OBC Crossbar Serial Mux

proj 879720

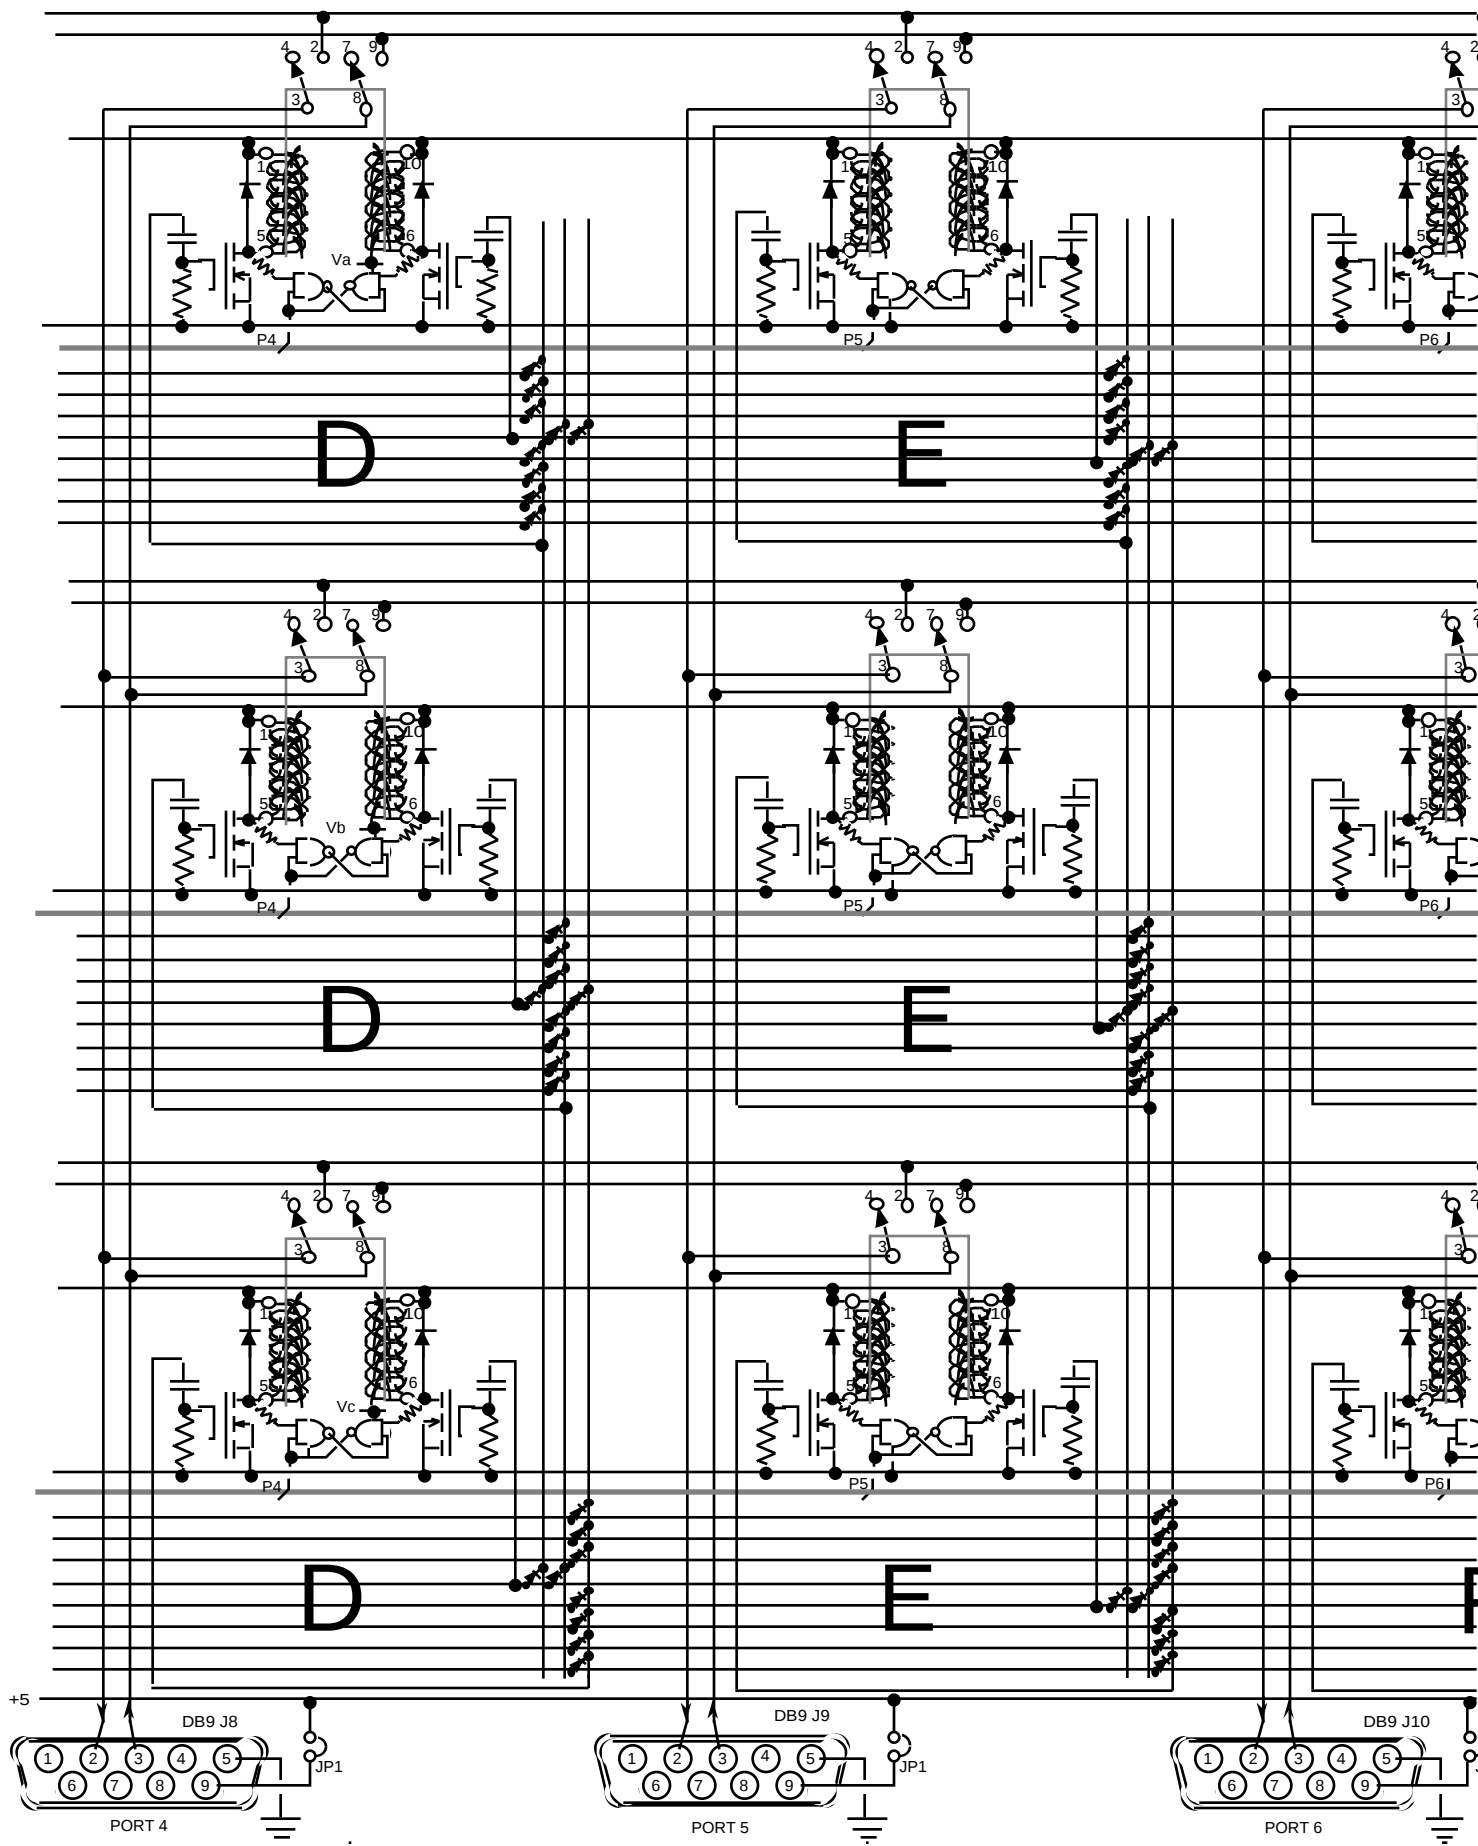
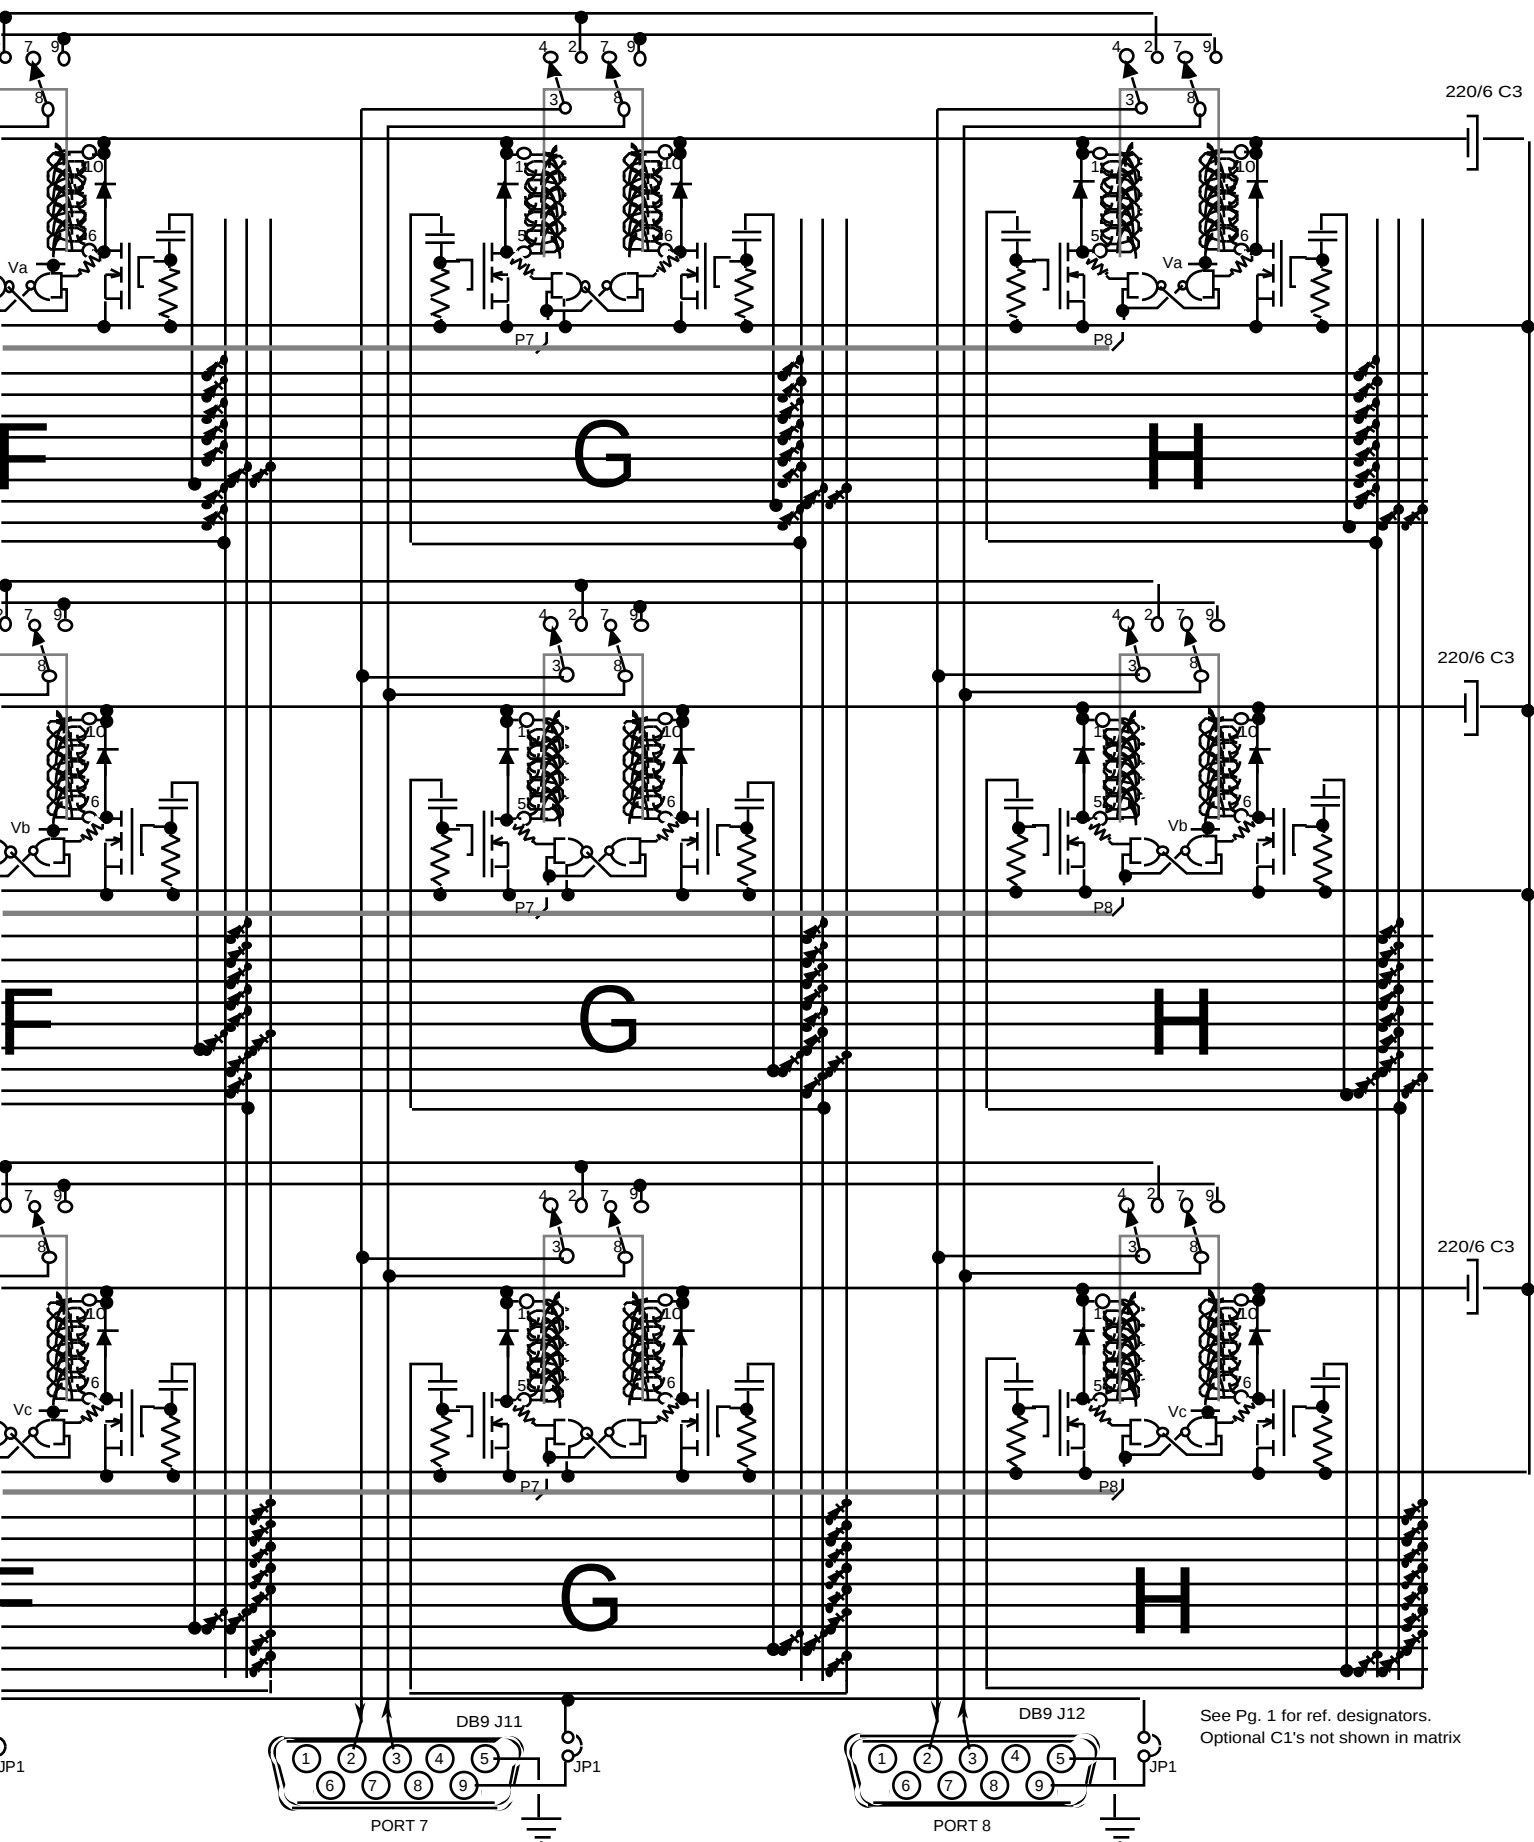
Rev 2 - relay drive on/off reversed, sense was not swapped
